# Access Compliance Report

## Public Rights-of-Way

### (Curb Ramps)

| Intersection ID: 10990                  | Main Street: BARRINGTON_DR | Cross Street: LANECREST_DR              | Location: SW           |

| ADA ID: C4109736EBD6                    | Ramp Type: Directional1    | Initial Pass/Fail: Fail                 | Overall Compliance: No |

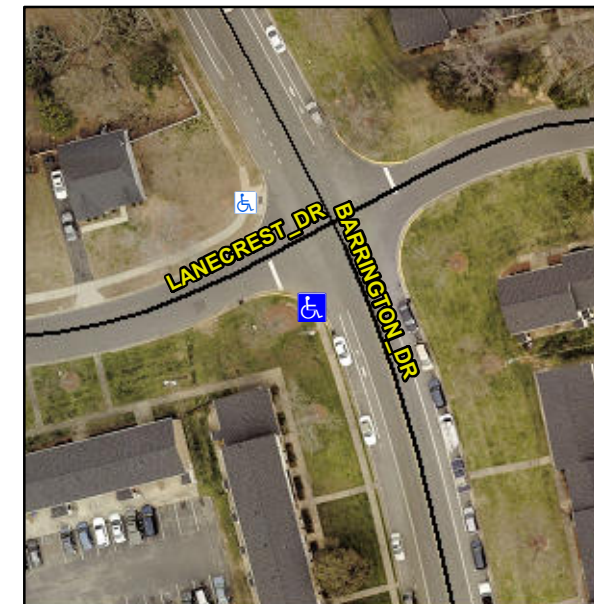
**LNDG LIP 1.0"**

**R304.5.1**

| Compliance | Description           | Data  | Compliance | Description                 | Data |
|------------|-----------------------|-------|------------|-----------------------------|------|
| No         | Ramp Width (in)       | 29.5  | N/A        | Grade Break Slope (%)       | 0.0  |

**Remove & Replace Entire Ramp.**
